Supporting information for EA Amendment (EPML00565813)

Dawson Mine

Supporting Information for Environmental Authority Amendment

Environmental Authority EPML00565813

Appendix B EA Table H1 Tracked Changes

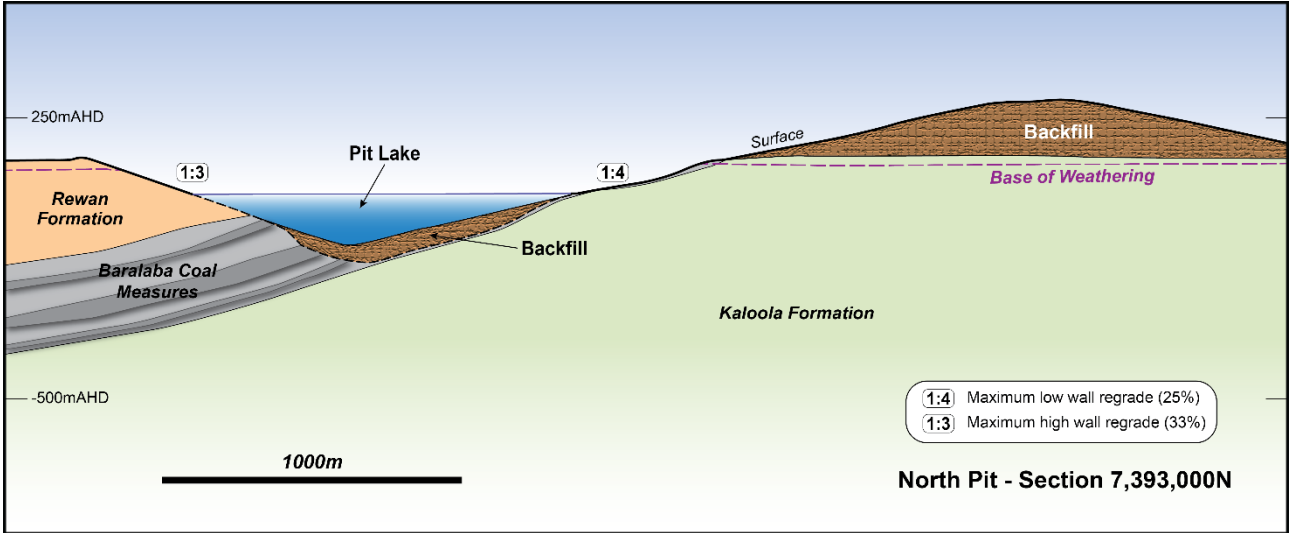
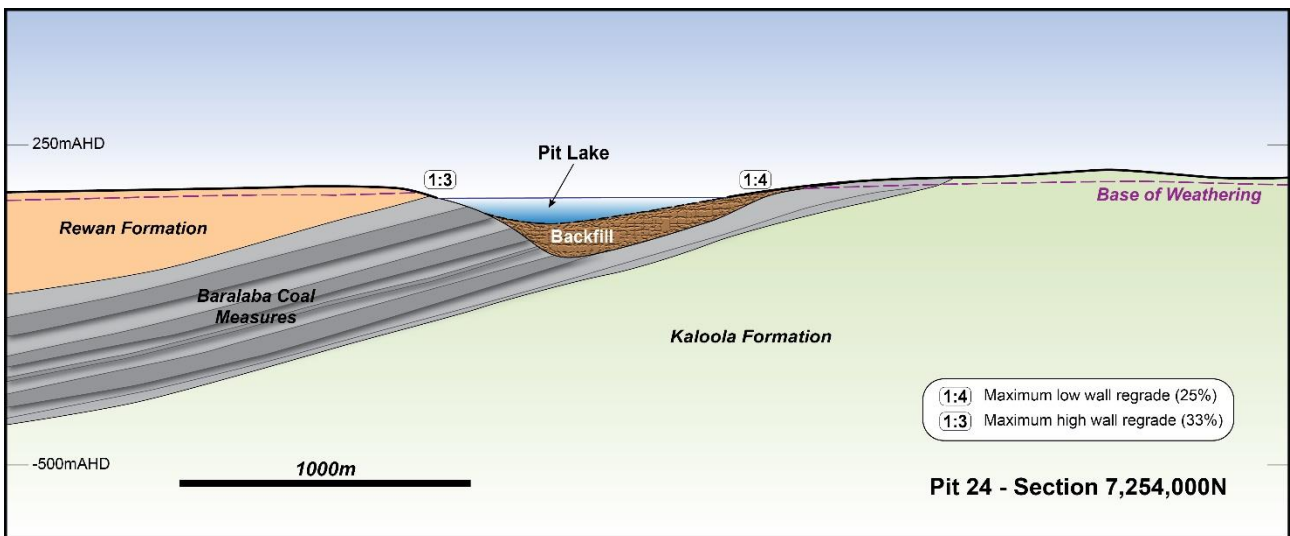
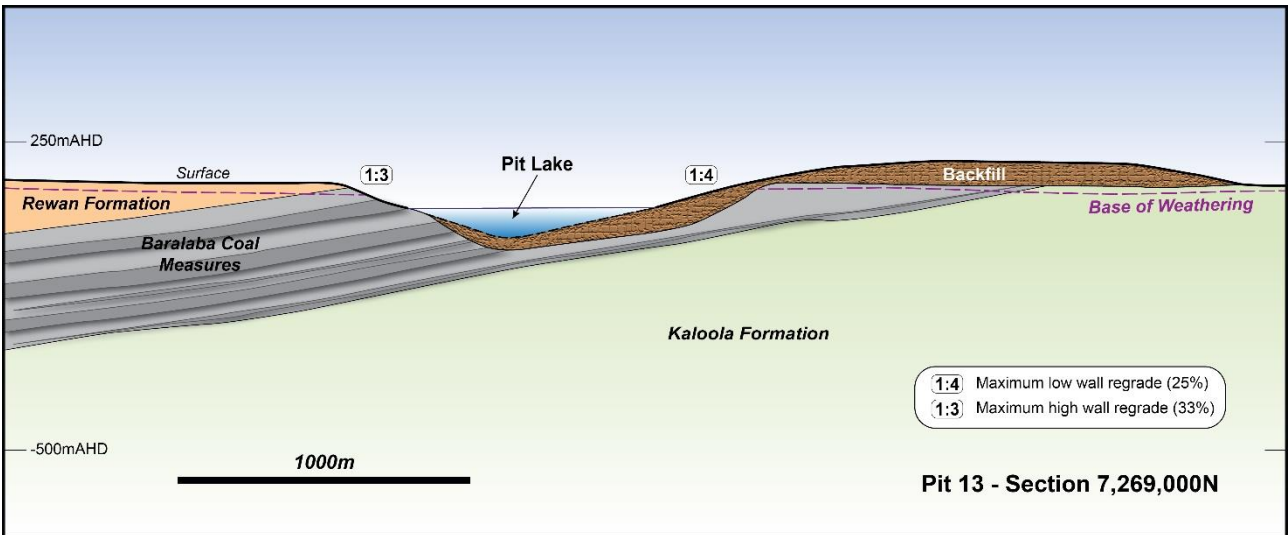
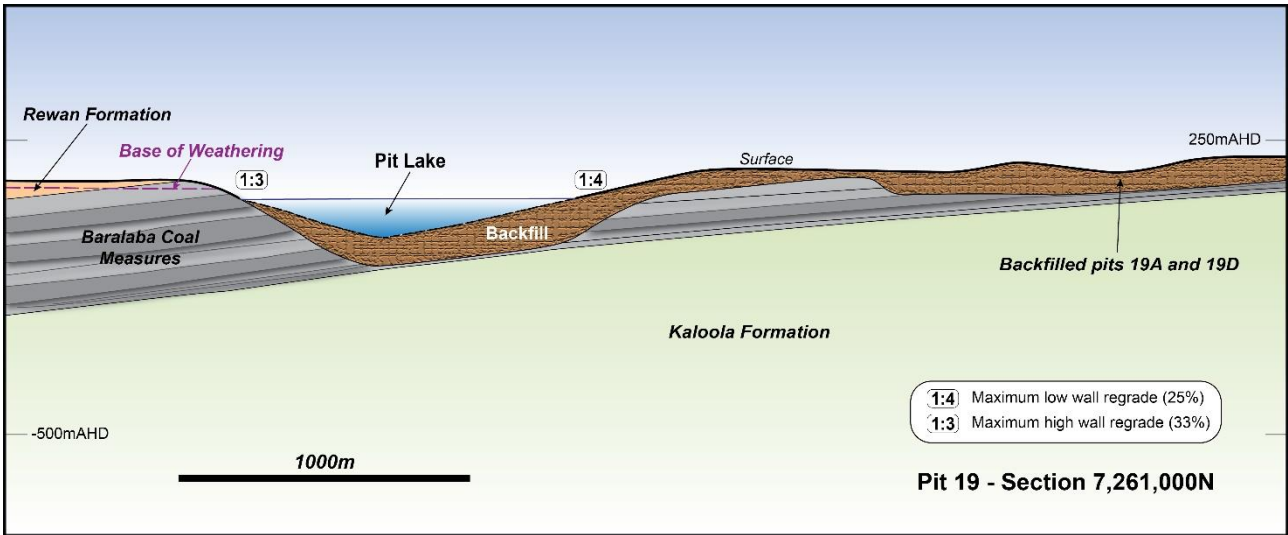
Anglo is seeking an amendment to 'Table H1 – Rehabilitation requirements' of the current EA to:

- reinstate the condition contained in Table H1 of the previous (pre-2014) environmental authorities authorising water storage in residual voids as a final rehabilitation outcome. These areas will be classified as NUMAs due to the expected final water quality;
- remove semi-evergreen vine thicket and hardwood plantations as potential rehabilitation objectives as these post mining land uses will be not adopted in the PRCP; and
- adjust the naming of the other two objectives for consistency with the neighbouring Dawson South Mine. These changes are administrative in nature with no change to indicators or completion criteria.

Table H1 of the Current EA is reproduced in Appendix B with the proposed changes reflected in 'mark up'.

Mine Domain	Mine Feature Name	Rehabilitation Goal	Rehabilitation Objectives	Indicators	Completion Criteria
Final Void Non-use Management Area (NUMA) [see also Figure 2]	<u>Residual Void</u>	<u>Safe and stable</u>	<u>Safe for humans and livestock</u>	<u>Geotechnically and erosionally stable</u>	<ul style="list-style-type: none"> a) <u>Maximum NUMA extent no greater than 1650ha projected surface area;</u> b) <u>Exposed coal seam is capped;</u>
		<u>Non-polluting</u>	<u>Void is a groundwater sink and does not overtop</u>	<u>Void modelling and monitoring</u>	<ul style="list-style-type: none"> c) <u>The void will not cause environmental harm outside of the relevant tenure boundary;</u> d) <u>The void water quality and quantity will not cause harm to the surrounding environment;</u> e) <u>Water levels within the residual voids are not predicted to exceed:</u> <ul style="list-style-type: none"> a. <u>North Pit - 66mRL</u> b. <u>Pit 2 - 116mRL</u> c. <u>Pit 3-12 - 94mRL</u> d. <u>Pit13 - 132mRL</u> e. <u>Pit 19 - 132mRL</u> f. <u>Pit 24 - 129mRL</u>

<u>Self-sustaining</u>	<u>Not Applicable</u>	<u>Not Applicable</u>	<u>Not Applicable</u>
